CIRNAC Comments to NIRB Re: Agnico Eagle Mines Limited's Meadowbank Complex Project 2024 Annual Report

Your file - Votre référence
03MN107 and 16MN056
Our file - Notre référence
GCdocs# 138849829

Re: Comment Request for Agnico Eagle Mines Limited's Meadowbank Complex Project 2024 Annual Report

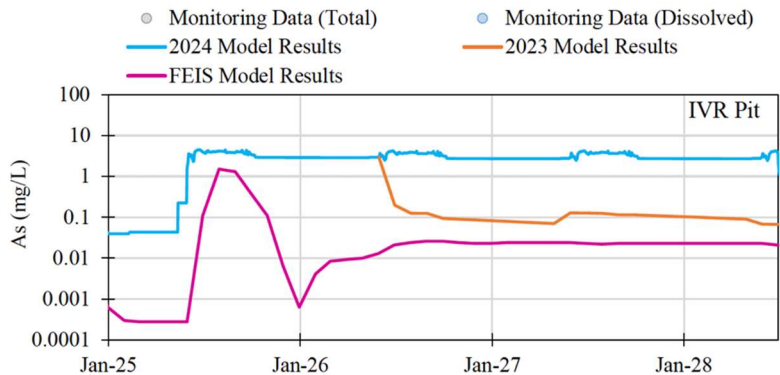
Comment Number:	CIRNAC #2
Subject:	Approval of Major Project Changes and Revised Management Plans
References:	<ul style="list-style-type: none"> • 2024 Annual Report • All Management Plans
Background/Rationale:	<p>The 2024 Annual Report introduces multiple major changes to the Meadowbank and Whale Tail Projects. For example, in the case of the Meadowbank Mine, the 2024 Annual Report indicates that AEM intends to make the following major changes to the closure approach for the site:</p> <ol style="list-style-type: none"> 1. Permanently storing contaminated water in the Vault Pit instead of treating and discharging it to the environment; and 2. Covering the Tailings Storage Facility (TSF) with a 1 m thick intrusion barrier instead of a thermal cover with a minimum thickness of 2 m, as agreed to during the original Project approval process. <p>Both of the above items represent major changes to the closure approaches described in the conceptual Closure and Reclamation Plan (CRP) and subsequent Interim Closure and Reclamation Plans (ICRPs) for the Meadowbank Mine. The major changes have yet to be approved through an approved Closure Plan.</p> <p>In addition to describing these unapproved changes throughout the Annual Report, numerous Management Plans submitted with the Annual Report also describe the changes as if they are part of the approved project. Furthermore, Sections 10.2.1 and 10.2.2 of the 2024 Annual Report with respect to the management plans state:</p> <p>“Plan(s) will be considered approved unless a notification from the NWB requested the formal approval process.”</p> <p>This implies that all changes presented in a revised Management Plan will</p>

Comment Number:	CIRNAC #2
	<p>automatically be classified as approved unless the Nunavut Water Board (NWB) requests that the plan undergo a formal approval process.</p> <p>It is CIRNAC's position that:</p> <ol style="list-style-type: none"> 1. Major project changes should be authorized only through appropriate application through the Institutes of Public Governance, including Project Certificate Amendments and/or Water Licence Amendments or Modifications; 2. Any Management Plans that are revised to reflect Major Project Changes must undergo a formal approval process by the NWB; and 3. Annual Report submissions are not the appropriate forum to review or approve Management Plans containing major changes to the scope of a project. Doing so requires reviewers to assess, and potentially discuss with the public, the technical implications of proposed project changes in the context of a process that is only intended to assess the annual performance of approved activities. <p>Given the implications of such changes, clear guidance on the appropriate pathways for their assessment—particularly in relation to the scope and intent of annual performance reviews—would help ensure that technical and regulatory considerations are adequately addressed through the proper channels.</p>

Recommendation:	CIRNAC recommends that the Nunavut Impact Review Board (NIRB) clarify whether the Annual Report review process is intended to encompass the review of significant project changes.
